TOWN OF PLAINFIELD DESIGN REVIEW COMMITTEE

CASE NO.: [DP-26-063](#)

Project Page: Village Pantry Refresh

REQUESTED ACTIONS: Development Plan Amendment approval for exterior building and site modifications to an existing legal nonconforming use.

OPTION 3: EIFS

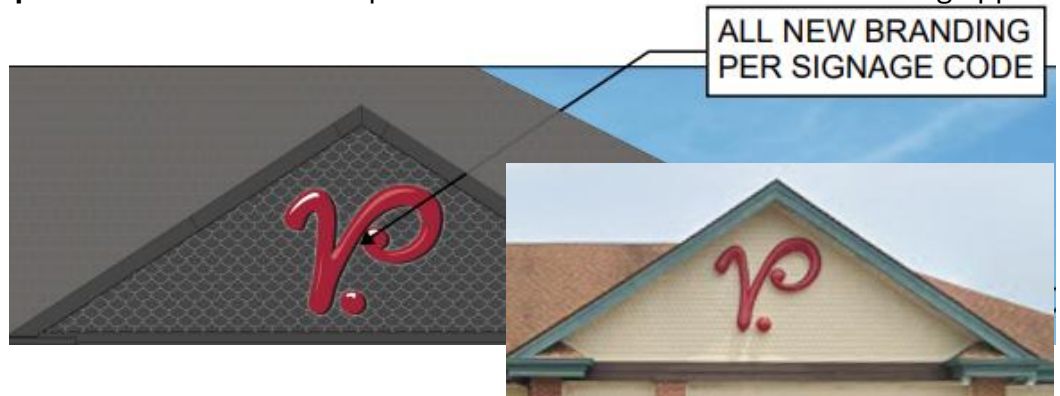
Option 3 utilizes the same proposed color palette and overall appearance as Option 1 but would achieve that result by installing EIFS over the existing brick rather than painting the masonry directly. While EIFS is an “Accepted” material within the Building Materials Matrix, it is not classified as a “Preferred” material and **would likely fail to meet** the Town’s architectural standards.

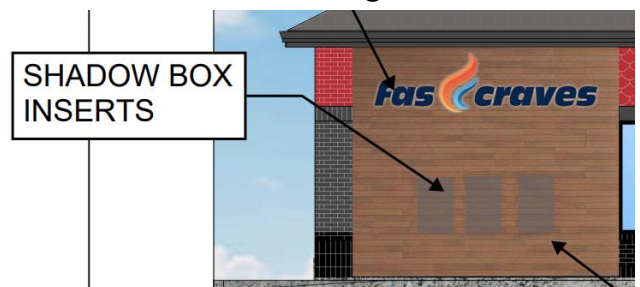
Second, the “Fas Craves” sign is proposed as a new wall sign. Due to the property’s legal nonconforming status, **any new signage requires a Variance of Development Standards from the Board of Zoning Appeals.**
